**RE: C.G.S. 8-24 Referral – Planning & Zoning
Sewer Main Extension – 19 Cannon Rd**

**GENERAL STATUTES § 7-246a APPLICATION OF
BAYWING L.L.C. FOR SEWER EXTENSION,
ALLOCATION OF
SEWER CAPACITY, AND APPROVAL TO CONNECT A
MULTI-FAMILY DEVELOPMENT
AT 19 CANNON ROAD, WILTON**

Re: Application of Baywing L.L.C. for Approval to Sewer Extension, Capacity Allocation, and Sewer Connection, 19 Cannon Road, Wilton

Sanitary Sewer Plan and Profile

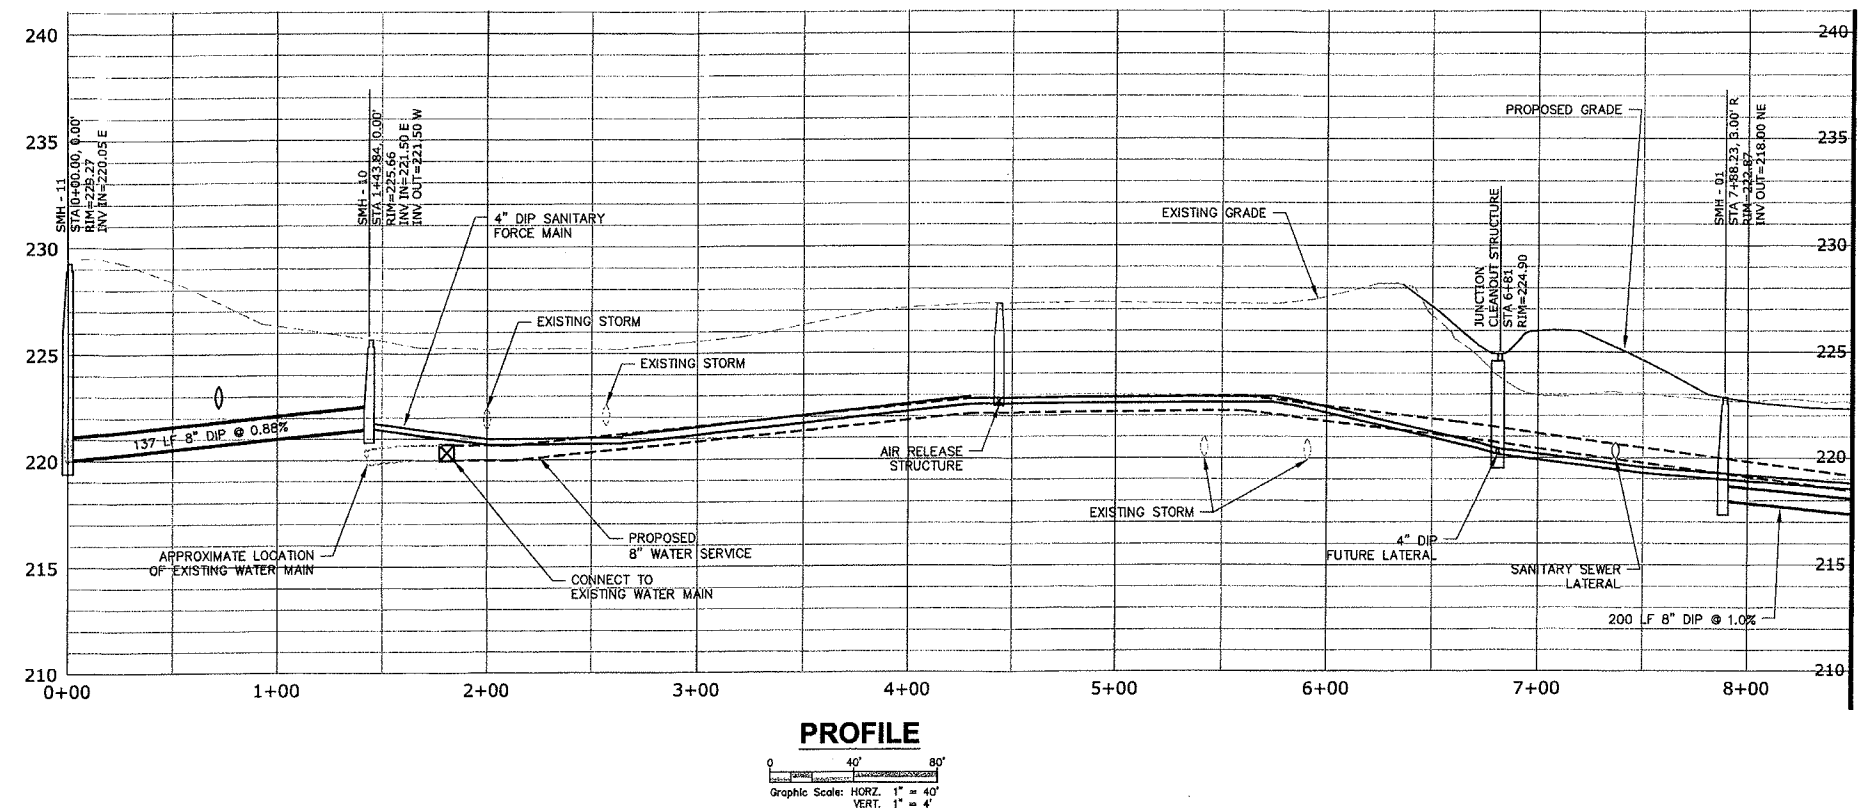
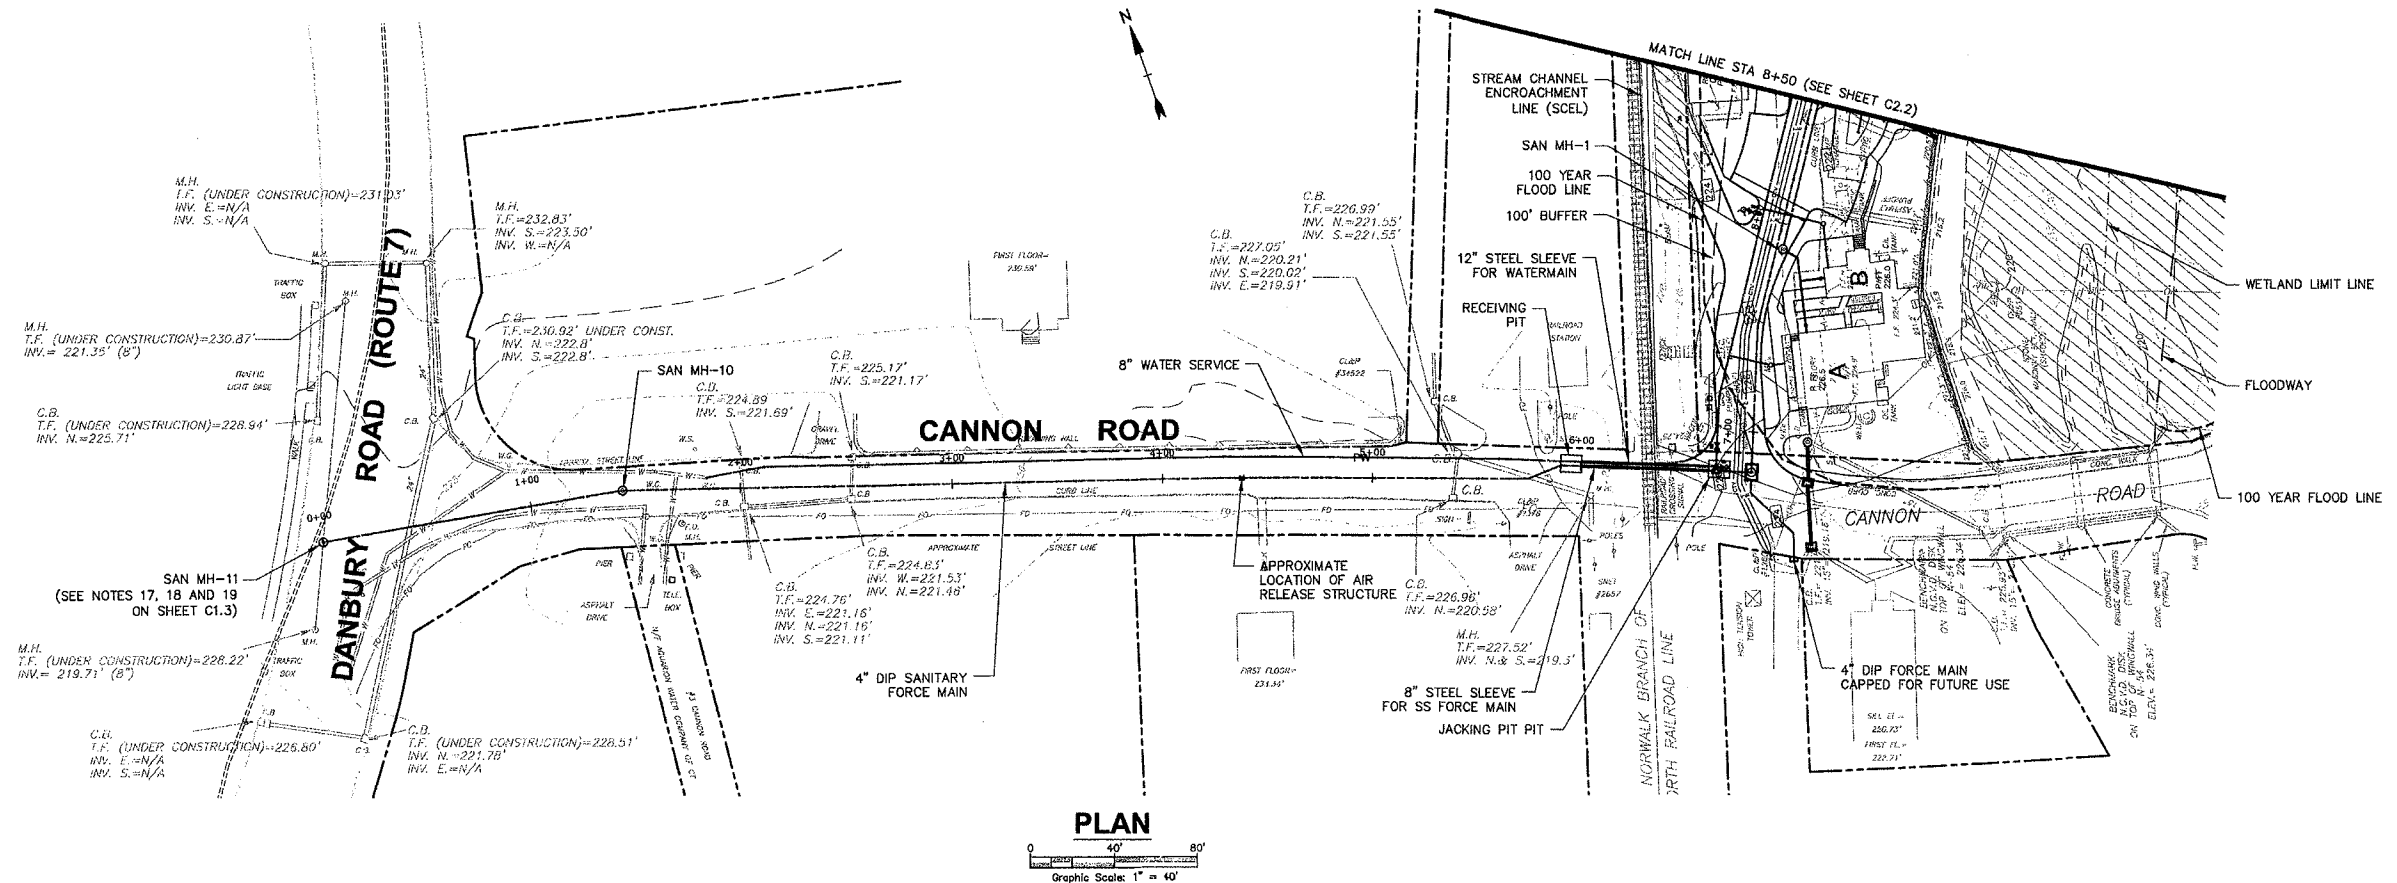
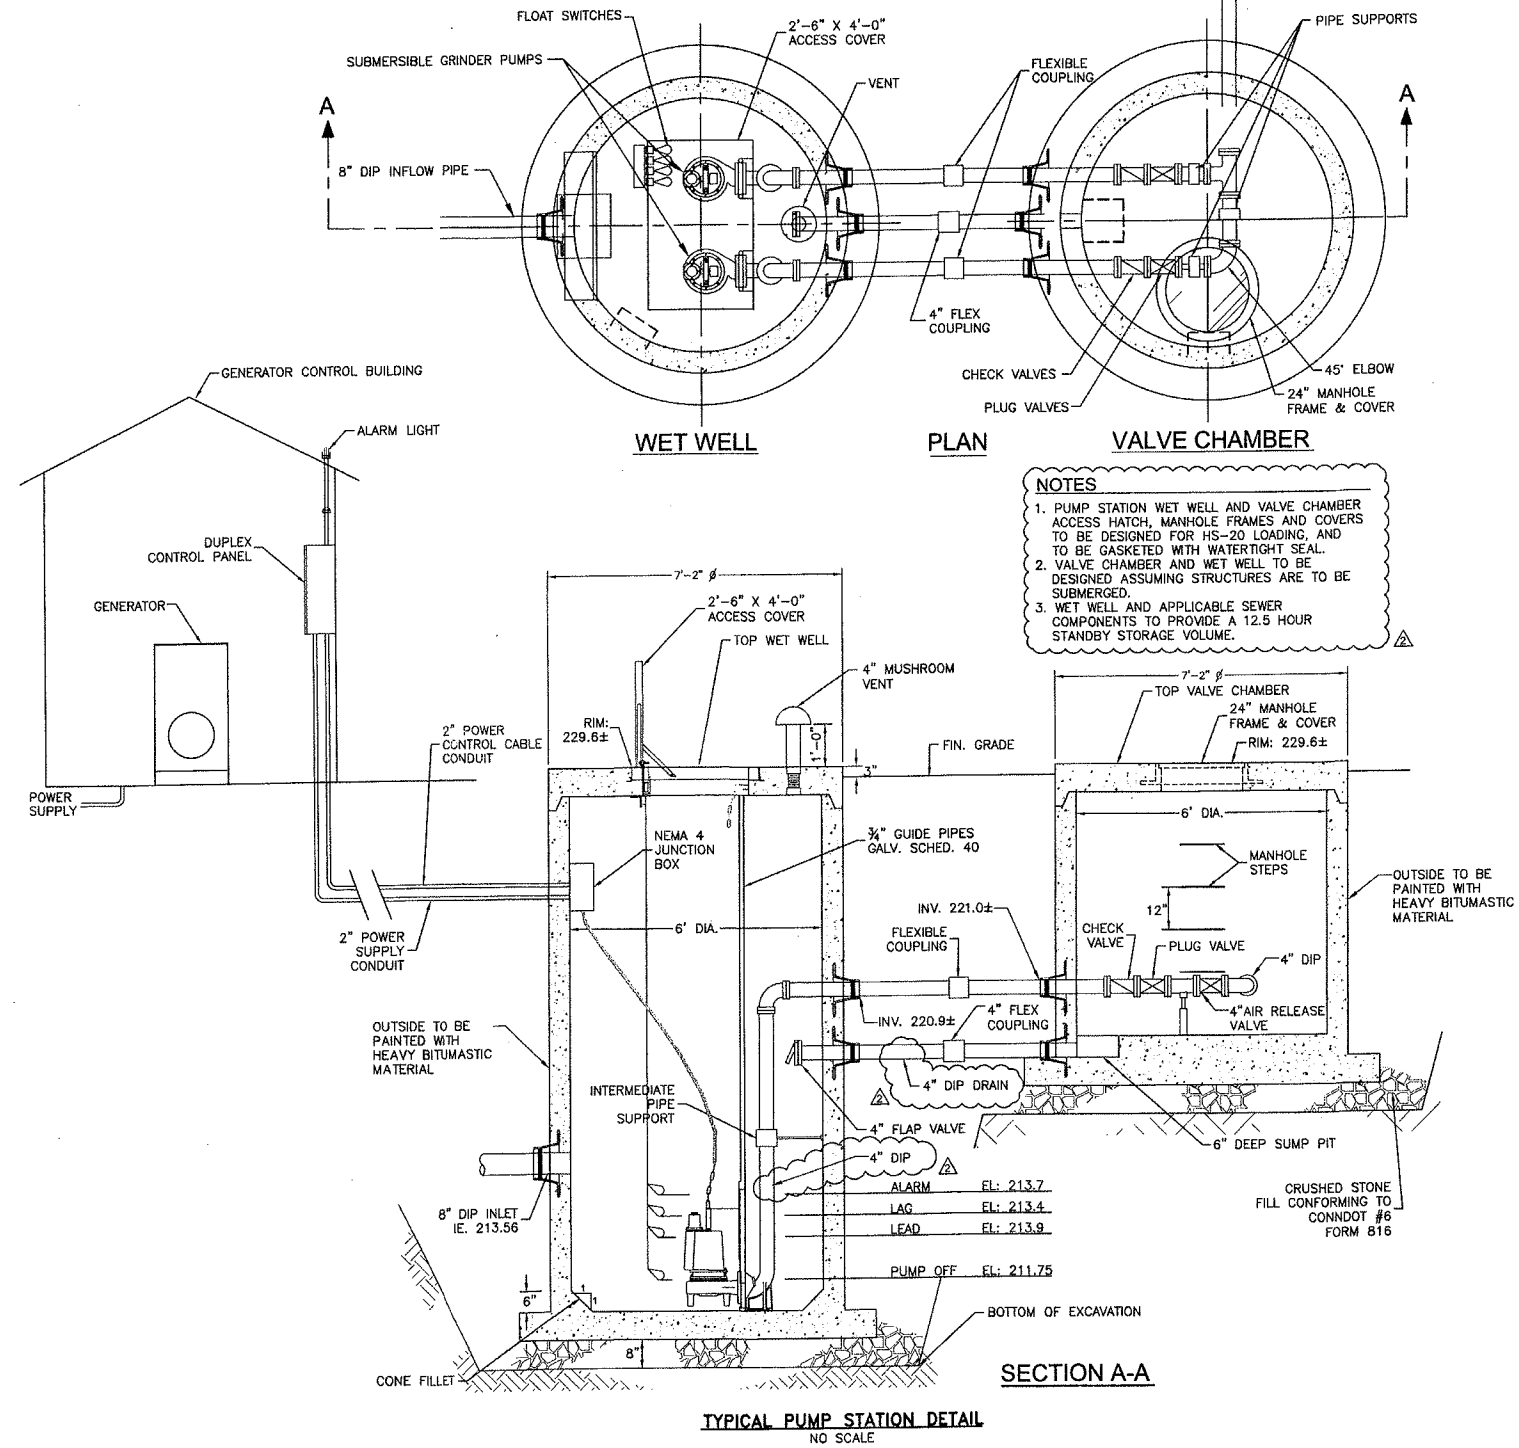
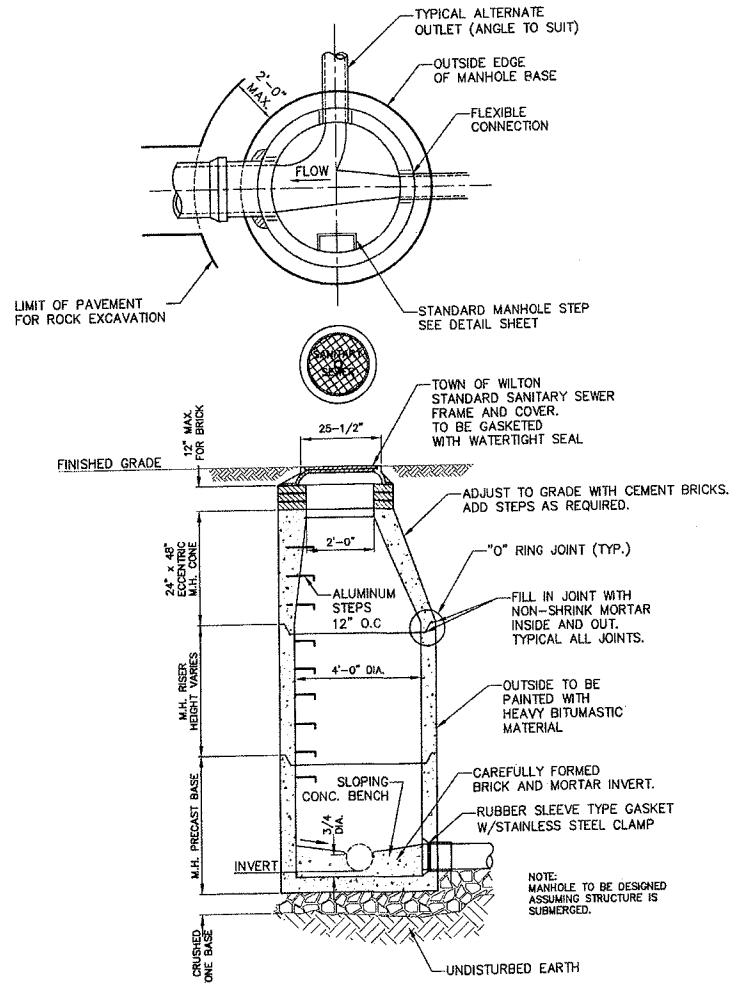
11. *Need valves added at connections just east of RR, with MHs for access. Confirm that terminal cleanout structure will be large enough to fit assembly.*

12. Add air release valve(s).

RESPONSE: A junction cleanout structure has been added just east of the railroad to accommodate the 4-inch valve for the Grange and the 4-inch valve for the proposed site. The terminal cleanout structure has been eliminated in favor of the junction cleanout structure and it will be adequate to accommodate the required fittings and appurtenances proposed.

RESPONSE: We have added two air release valves to the plan sheets. The first valve is located in the valve vault, and the second is located approximately at station 4+30.

Sanitary Sewer
Details

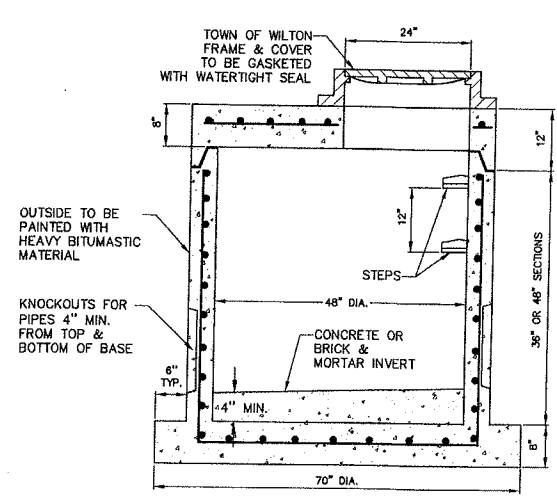
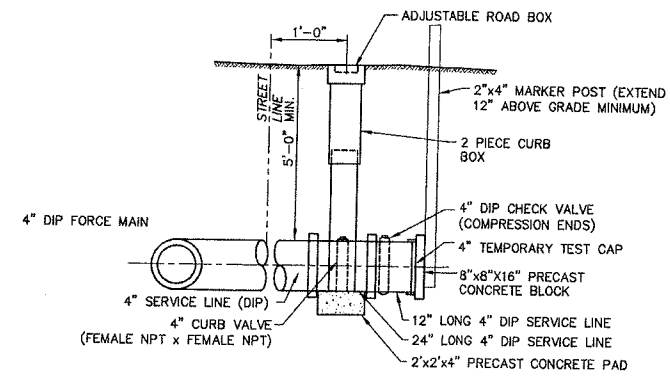
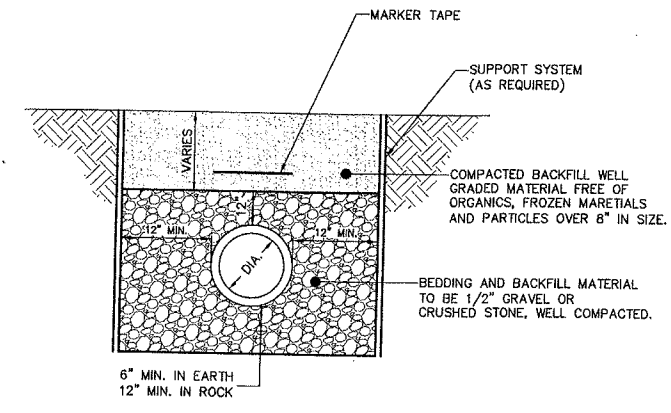
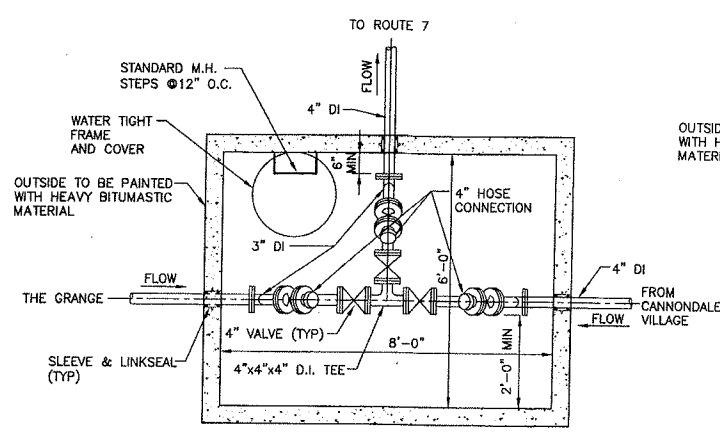
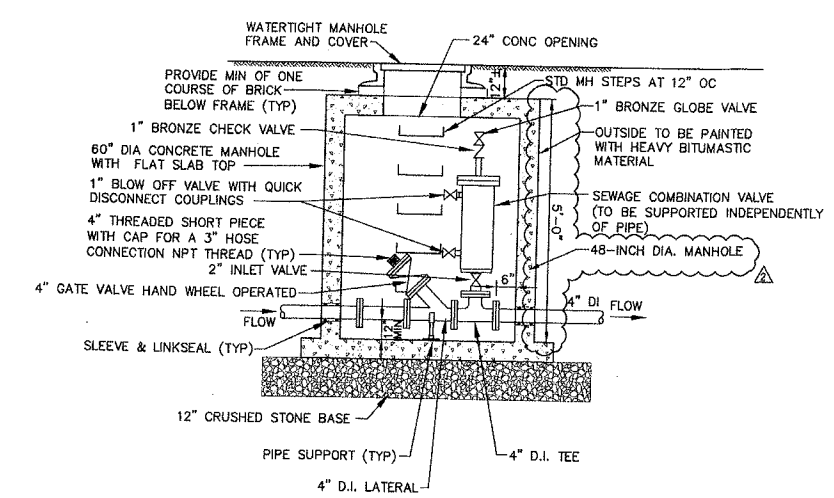
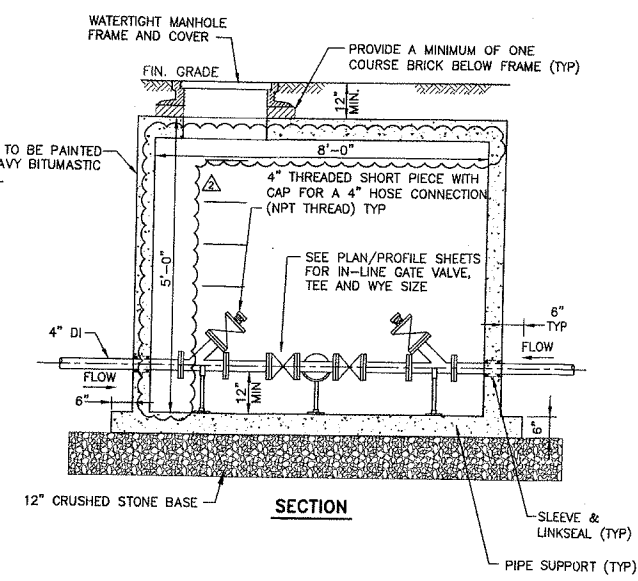
3. *Revise Plans to show watertight manhole covers and hatches.*

4. *Revise plans to show waterproof wet well structures and connections.*

4. *Please identify discharge pipe size and material inside the wet well on drawing number C-4.4.*

5. *Add overall dimensions to junction cleanout and air release structure details on drawing number C-4.5.*

RESPONSE: We have revised the detail sheet to incorporate this comment.

RESPONSE: We have revised the detail sheet to incorporate this comment.

RESPONSE: We have revised the detail sheet to incorporate this comment.

RESPONSE: We have revised the detail sheet to incorporate this comment.
